**ADDENDUM #5**

**TITLE: Design Build Services for East Bay Bike Path Bridge  
Replacement**

**RFP #7670815 – DESIGN BUILD SERVICES FOR EAST BAY BIKE PATH BRIDGE REPLACEMENT**

Per issuance of **ADDENDUM #5** the following revisions are noted:

**EAST BAY BIKE PATH  
BRIDGE NOs. 837 & 838 REPLACEMENT**  
BARRINGTON/WARREN BRIDGE 083751  
RHODE ISLAND  
**TYPICAL SECTION AND PROFILE**

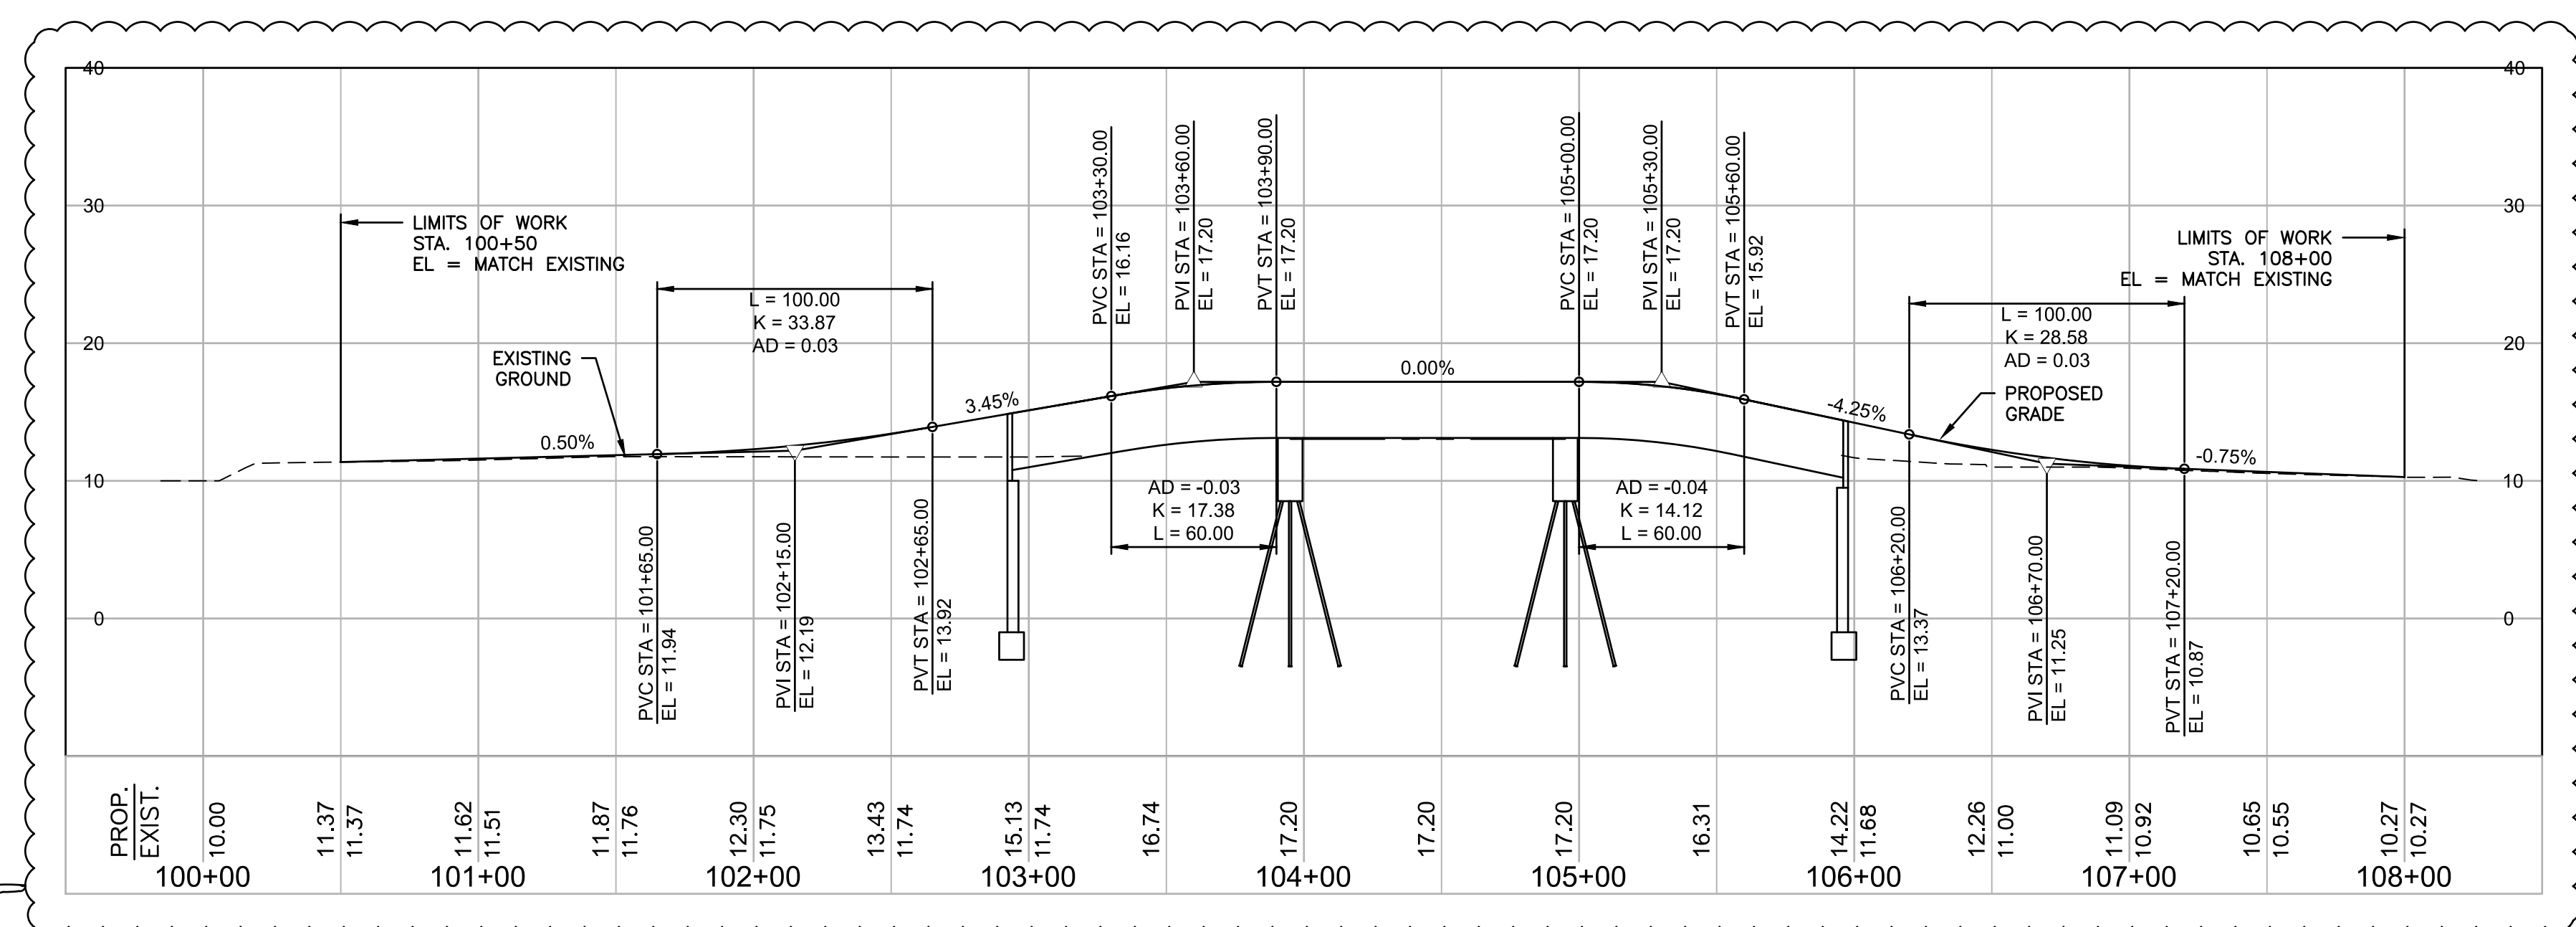
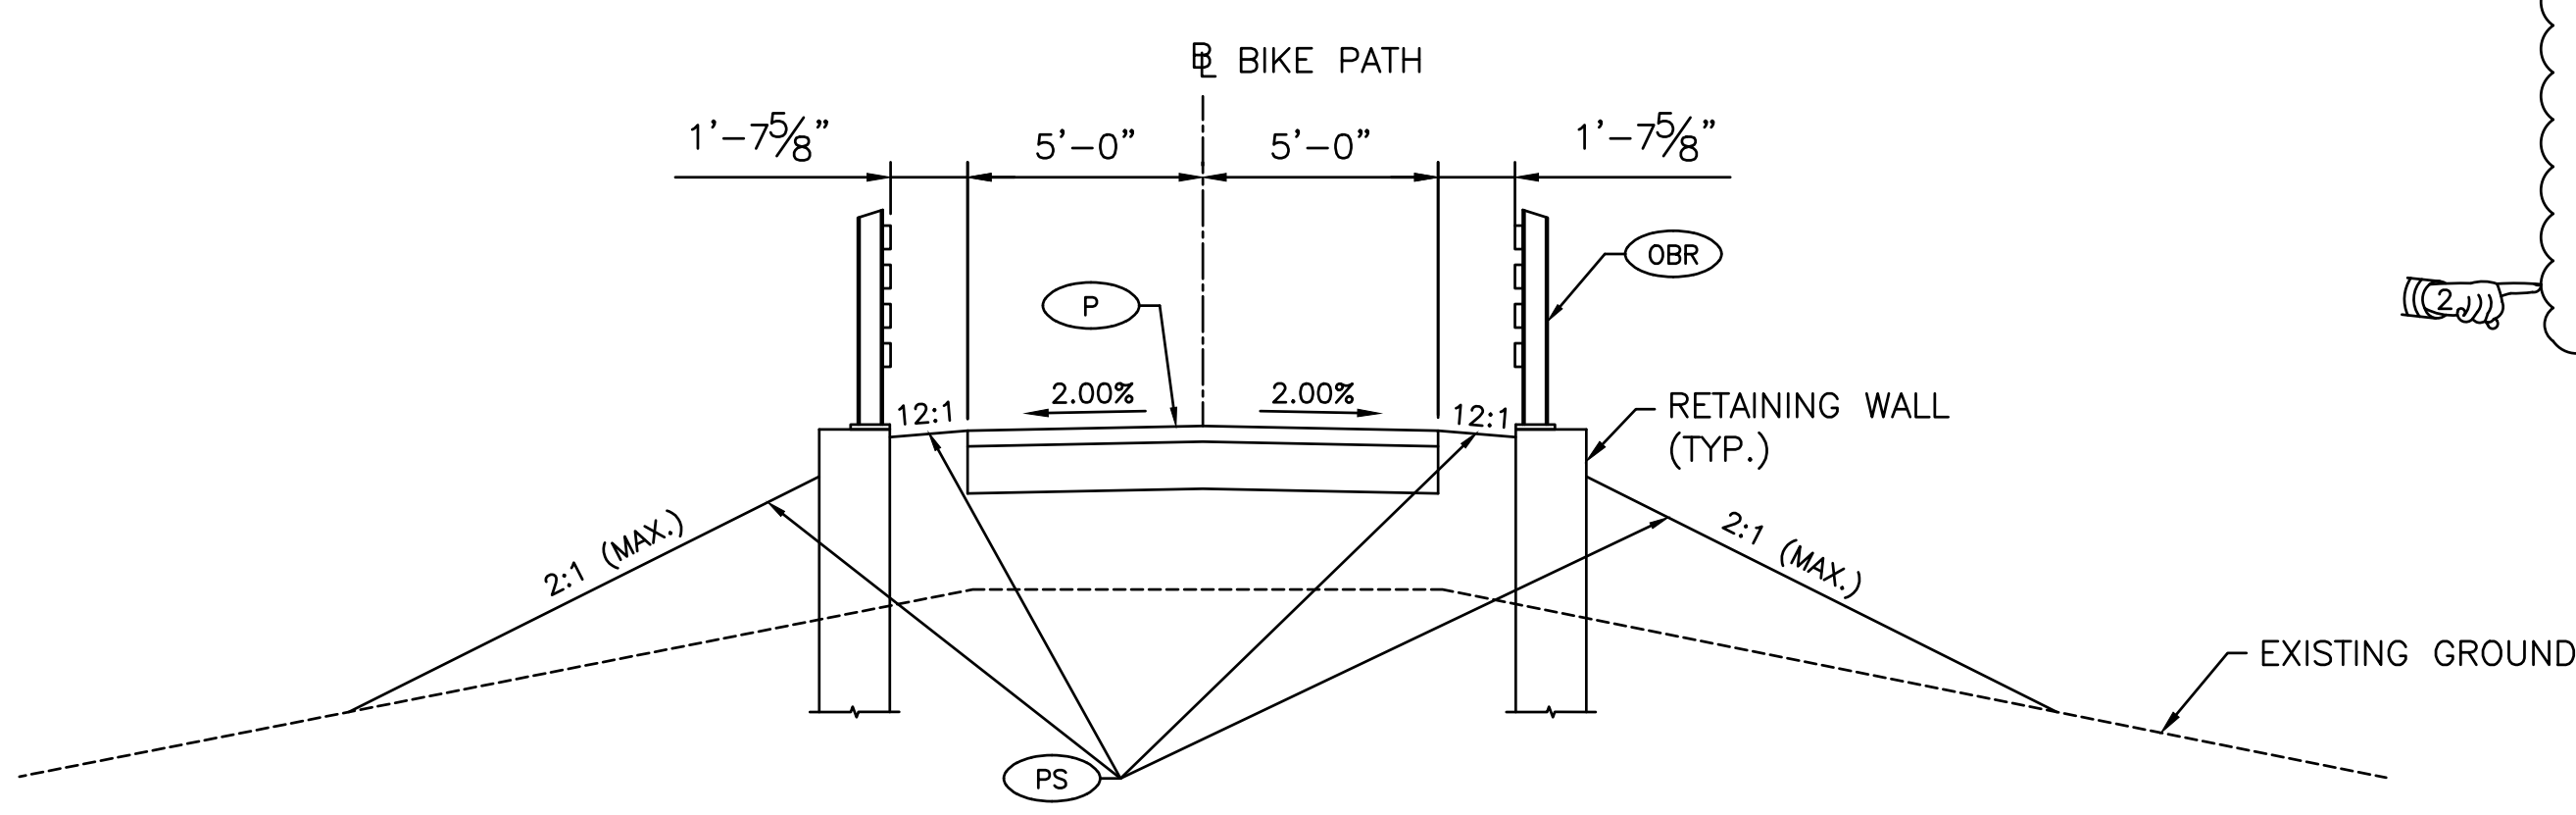
1. RFP Part 2 Revised Section 1.4.5, Section 4.3, Section 4.6.1, and Section 4.6.3
2. BTC Plans Revised superstructure beam depth to accommodate underground utilities.
3. Appendix B.05 Added NMFS Endangered Species Act and Essential Fish Habitat Protection
4. Appendix B.05 Added USCG Permit Exemption Request and Approval Letters
5. Appendix B.05 Added USCG General Construction Requirements
6. Appendix B.06 Revised TMP Attachment A – Restriction Table
